File In Section: Product Recalls
Bulletin No.: 09048
Date: April 2009

PRODUCT SAFETY RECALL

SUBJECT: Fuel Tank Front Support Strap Fracture – Install New Strap

MODELS: 2009 HUMMER H3T

2245346

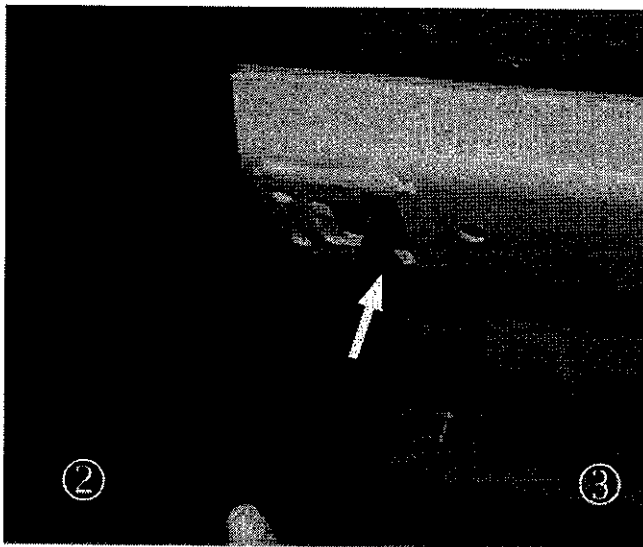
8. Install the new fuel tank front strap.

- (1) Frame Crossmember Slot Large Section
- (2) Driver Side
- (3) Passenger Side

8.1. Position the new fuel tank strap below the frame crossmember slot large section (1).

2245348

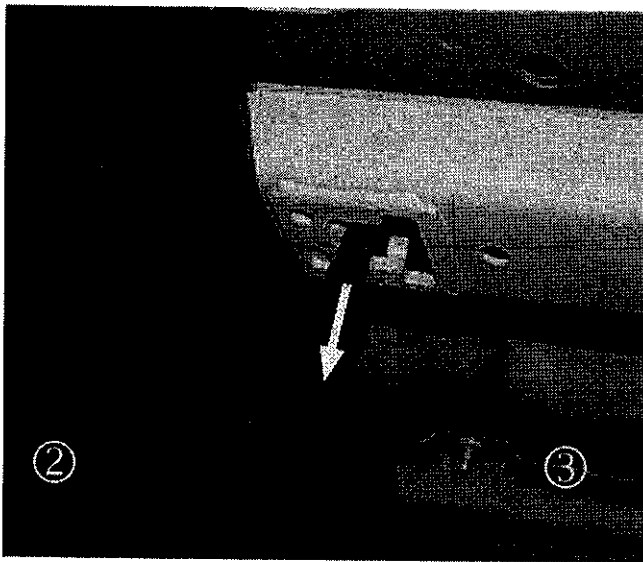
- 8.2. Move the new fuel tank front strap up until it touches the frame crossmember upper surface.

(1) Frame Crossmember Slot Narrow Section
(2) Driver Side
(3) Passenger Side

2245349

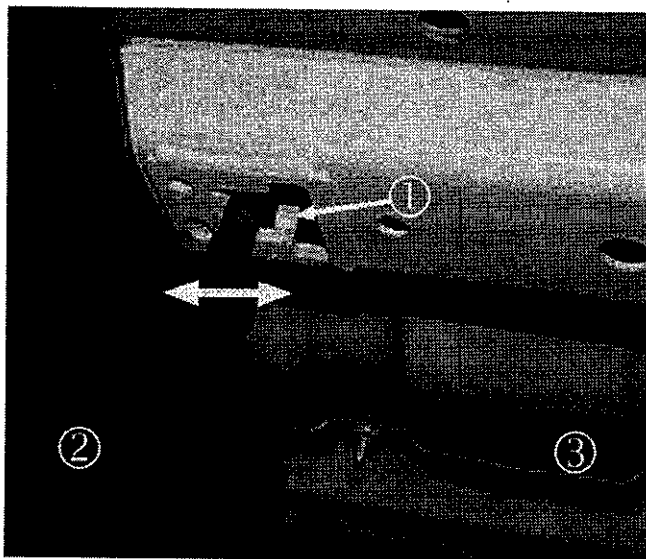
- 8.3. Move the new fuel tank front strap towards the driver side of the vehicle until it touches the frame crossmember slot narrow section edge.

2245350

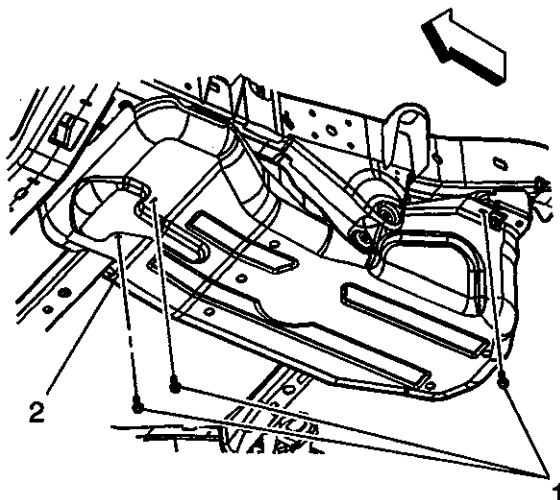
8.4. Pull the new fuel tank front strap down until it stops.

(1) Locking Tab
(2) Driver Side
(3) Passenger Side

8.5. VERIFICATION: pulling the strap down (position shown in Step 8.4), move the strap side to side (passenger side-driver side-passenger side). The strap will be located on the driver side of the locking tab.
